# NEW MILFORD ROAD SAFETY AUDIT

US Route 7 / US Route 202 (Danbury Road): Veteran's Memorial Bridge to Brookfield Town Line

OCTOBER 2024

Exhibit 26: Veteran's Memorial Bridge Recommendations

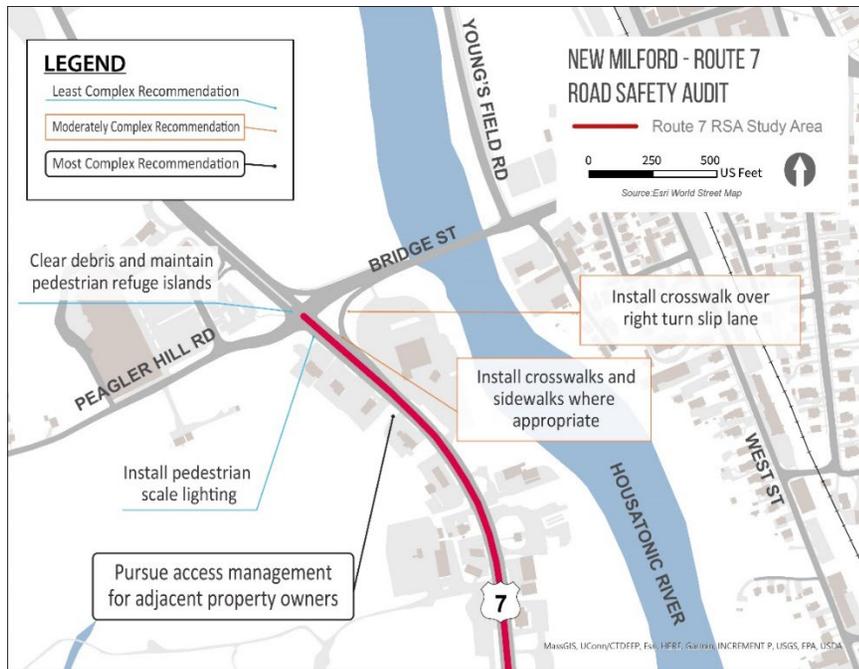
- 1) Install pedestrian scale lighting to increase visibility of vulnerable road users. Note: CTDOT EB-2024-1 requires roadway lighting at all new pedestrian crosswalks across state roads, in conformance with the Engineering & Construction Directive ECD-2023-8.

- **Next Step:** LTA to contact [DOT.TrafficEngineering@ct.gov](mailto:DOT.TrafficEngineering@ct.gov)
- 3) Provide consistent 11' travel lanes, 10' turning lanes, 3' buffer, and 5' bike lanes where feasible. See Exhibit 24 for concept details.

- 1) Install crosswalks, sidewalks, and pedestrian refuge islands on medians where feasible.
  - **Next Step:** Municipality to contact [Western Connecticut Council of Governments Regional Planning Agency](#) for potential funding sources
  - **Next Step:** Municipality to check available ROW and roadside area for feasibility

- 2) Install a signed, painted, uncontrolled crosswalk over the right turn slip lane that provides northbound access to the Veteran’s Memorial Bridge.

- 1) Pursue access management for adjacent property owners to reduce the number of conflicting movements with roadway traffic.

*Exhibit 27: Sunny Valley Road Recommendations*

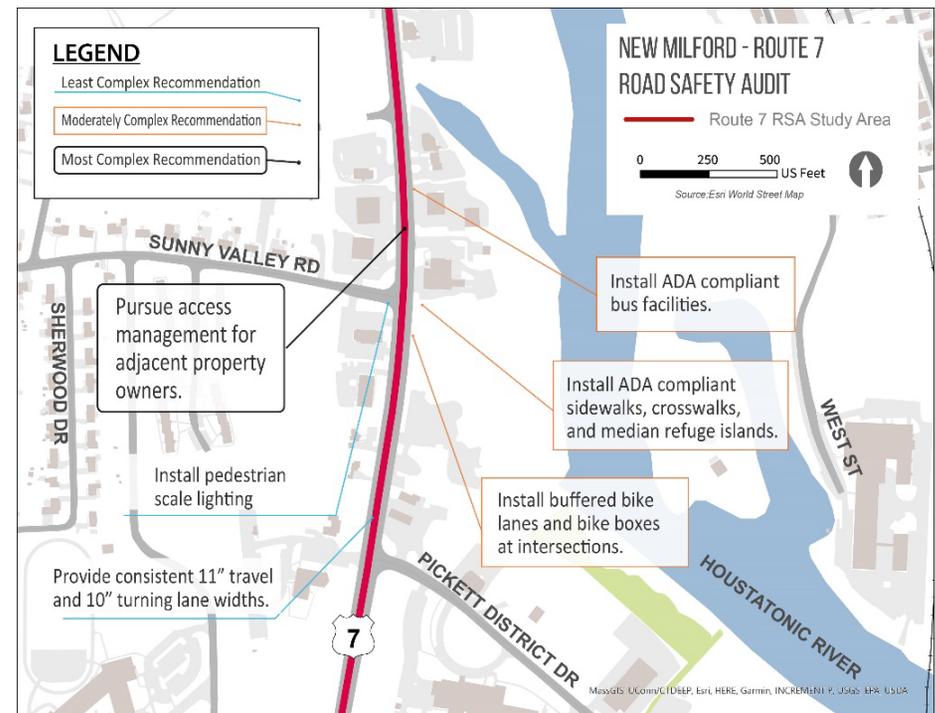
- 1) Install pedestrian scale lighting to increase visibility of vulnerable road users. Note: CTDOT EB-2024-1 requires roadway lighting at all new pedestrian crosswalks across state roads, in conformance with the Engineering & Construction Directive ECD-2023-8.
  - **Next Step:** Municipality to consider applying for an [Encroachment Permit](#) through the District permit office

- 2) Provide consistent 11’ travel lanes, 10’ turning lanes, 3’ buffer, and 5’ bike lanes. See Exhibit 24 for concept details.

- 1) Install ADA-compliant bus stop pad.
  - **Next Step:** Municipality to contact [DOT.BusStops@ct.gov](mailto:DOT.BusStops@ct.gov) to coordinate with CTDOT to identify bus stop enhancements

- 2) Install ADA-compliant pedestrian accommodations such as crosswalks, sidewalks, curb ramps, signal push buttons, medians, and pedestrian refuge islands. Note: CTDOT EB-2024-1 requires roadway lighting at all new pedestrian crosswalks across state roads, in conformance with the Engineering & Construction Directive ECD-2023-8.

- **Next Step:** Municipality to consider applying for an [Encroachment Permit](#) through the District permit office
- 3) Install buffered bike lanes, and bike boxes at intersections. See concept detail in Exhibit 24.

- 1) Pursue access management for adjacent property owners to reduce the number of conflicting movements with roadway traffic.
  - **Next Step:** Municipality to initiate and coordinate access management with adjacent property owners
  - **Next Step:** LTA to coordinate with CTDOT Office of State Traffic Administration at [DOT.OSTA@ct.gov](mailto:DOT.OSTA@ct.gov) on need for traffic signal revisions

Exhibit 28: New Milford Plaza Recommendations

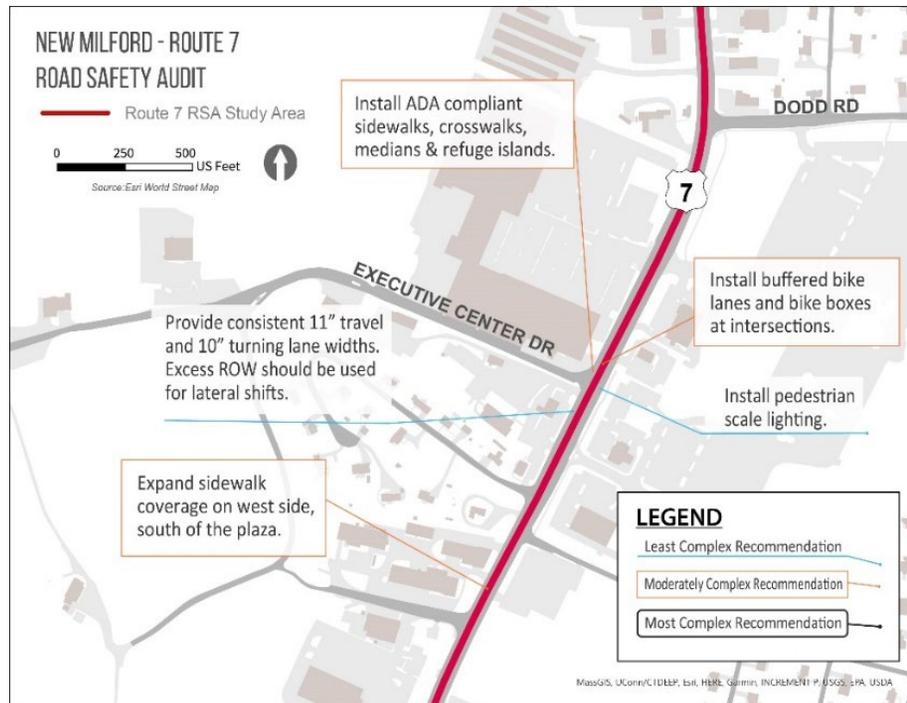
- 2) Install pedestrian scale lighting to increase visibility of vulnerable road users. Note: CTDOT EB-2024-1 requires roadway lighting at all new pedestrian crosswalks across state roads, in conformance with the Engineering & Construction Directive ECD-2023-8.

- 1) Install ADA-compliant pedestrian accommodations such as crosswalks, sidewalks, curb ramps, signal push buttons, medians, and pedestrian refuge islands. Note: CTDOT EB-2024-1 requires roadway lighting at all new pedestrian crosswalks across state roads, in conformance with the Engineering & Construction Directive ECD-2023-8.

- 2) Expand sidewalk coverage on the west side of US Route 7 south of New Milford Plaza.
  - **Next Step:** Municipality to research available ROW for feasibility
  - **Next Step:** Municipality to research and apply for an [Encroachment Permit](#)
- 3) Install buffered bike lanes and bike boxes at the intersection to the plaza.
  - **Next Step:** Municipality to contact [Western Connecticut Council of Governments Regional Planning Agency](#) for potential funding sources
  - **Next Step:** Municipality to check available ROW and roadside area for feasibility
  - **Next Step:** Municipality to consider applying for an [Encroachment Permit](#) through the District permit office

- 1) Pursue access management for adjacent property owners to reduce the number of conflicting movements with roadway traffic.
  - **Next Step:** Municipality to initiate and coordinate access management with adjacent property owners
  - **Next Step:** LTA to coordinate with CTDOT Office of State Traffic Administration at [DOT.OSTA@ct.gov](mailto:DOT.OSTA@ct.gov) on need for traffic signal revisions

Exhibit 29: Willow Springs Condominiums Recommendations

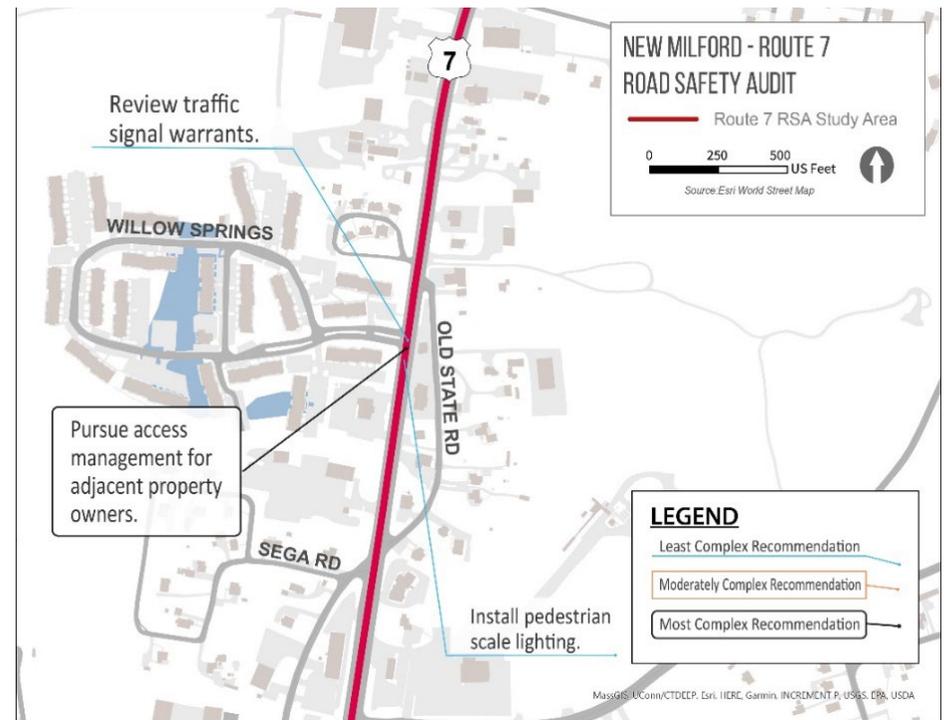
- 1) Install pedestrian scale lighting to increase visibility of vulnerable road users. Note: CTDOT EB-2024-1 requires roadway lighting at all new pedestrian crosswalks across state roads, in conformance with the Engineering & Construction Directive ECD-2023-8.

- **Next Step:** Municipality to consider applying for an [Encroachment Permit](#) through the District permit office
- 2) Provide consistent 11' travel lanes, 10' turning lanes, 3' buffer, and 5' bike lanes. See Exhibit 24 for concept details.

- 1) Install ADA-compliant pedestrian accommodations such as crosswalks, sidewalks, curb ramps, signal push buttons, medians, and pedestrian refuge islands. Note: CTDOT EB-2024-1 requires roadway lighting at all new pedestrian crosswalks across state roads, in

- 2) Create a green median to break up travel lanes in support of appropriate lane widths. S
  - **Next Step:** Municipality to contact [Western Connecticut Council of Governments Regional Planning Agency](#) for potential funding sources
  - **Next Step:** Municipality to check available ROW and roadside area for feasibility
  - **Next Step:** Municipality to coordinate with CTDOT for feasibility

- 1) Pursue access management for adjacent property owners to reduce the number of conflicting movements with roadway traffic.
  - **Next Step:** Municipality to initiate and coordinate access management with adjacent property owners
  - **Next Step:** LTA to coordinate with CTDOT Office of State Traffic Administration at [DOT.OSTA@ct.gov](mailto:DOT.OSTA@ct.gov) on need for traffic signal revisions

*Exhibit 30: Still River Drive Recommendations*

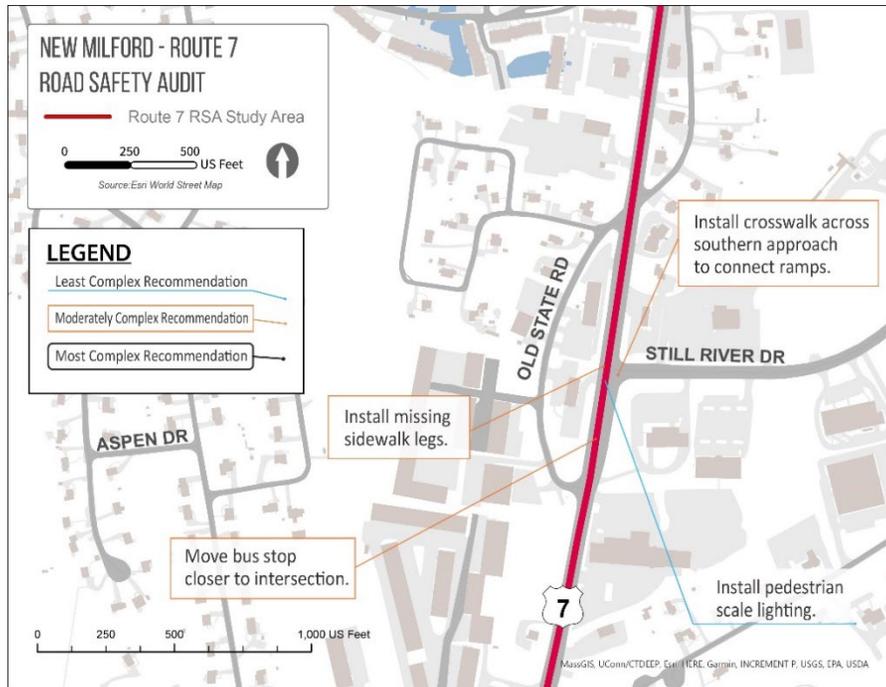
- 1) Install pedestrian scale lighting to increase visibility of vulnerable road users. Note: CTDOT EB-2024-1 requires roadway lighting at all new pedestrian crosswalks across state roads, in conformance with the Engineering & Construction Directive ECD-2023-8.
  - **Next Step:** Municipality to consider applying for an [Encroachment Permit](#) through the District permit office

- 1) Install appropriate ADA-compliant crosswalk, median, refuge islands, and push buttons across the southern approach to complete connection to curb ramps. Note: CTDOT EB-2024-1 requires roadway lighting at all new pedestrian crosswalks across state roads, in conformance with the Engineering & Construction Directive ECD-2023-8. See Exhibit for concept details on median island.

- **Next Step:** Municipality to consider applying for an [Encroachment Permit](#) through the District permit office
- 2) Install missing sidewalk legs along the western side of US Route 7 and the eastern side north of Still River Drive.

- 3) Move bus stop closer to intersection for better access to crosswalks and other pedestrian facilities. Upgrade ADA-compliance with applicable standards.

Exhibit 31: New Milford High School Recommendations

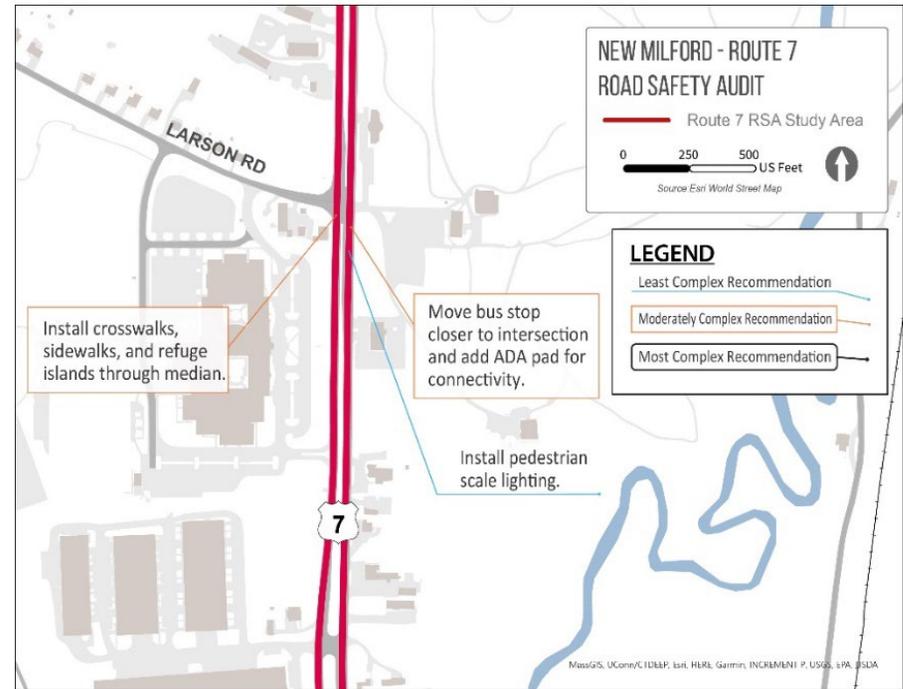
- 1) Install pedestrian scale lighting to increase visibility of vulnerable road users. Note: CTDOT EB-2024-1 requires roadway lighting at all new pedestrian crosswalks across state roads, in conformance with the Engineering & Construction Directive ECD-2023-8.
  - **Next Step:** Municipality to consider applying for an [Encroachment Permit](#) through the District permit office

- 1) Install appropriate ADA-compliant crosswalks, sidewalks, refuge islands, and push buttons across the median to complete connection to curb ramps. Note: CTDOT EB-2024-1 requires roadway lighting at all new pedestrian crosswalks across state roads, in conformance with the Engineering & Construction Directive ECD-2023-8. See Exhibit 25 for concept details on median island.
  - **Next Step:** Municipality to contact [Western Connecticut Council of Governments Regional Planning Agency](#) for potential funding sources
  - **Next Step:** Municipality to check available ROW and roadside area for feasibility
  - **Next Step:** Municipality to consider applying for an [Encroachment Permit](#) through the District permit office

- 2) Move bus stop closer to intersection for better access to crosswalks and other pedestrian facilities. Upgrade ADA-compliance with applicable standards.
  - **Next Step:** Municipality to contact [DOT.BusStops@ct.gov](mailto:DOT.BusStops@ct.gov) to coordinate with CTDOT and discuss potential bus stop enhancements
  - **Next Step:** Municipality to contact [Western Connecticut Council of Governments Regional Planning Agency](#) for potential funding sources
  - **Next Step:** Municipality to research available ROW for feasibility
  - **Next Step:** Municipality to consider applying for an [Encroachment Permit](#) through the District permit office
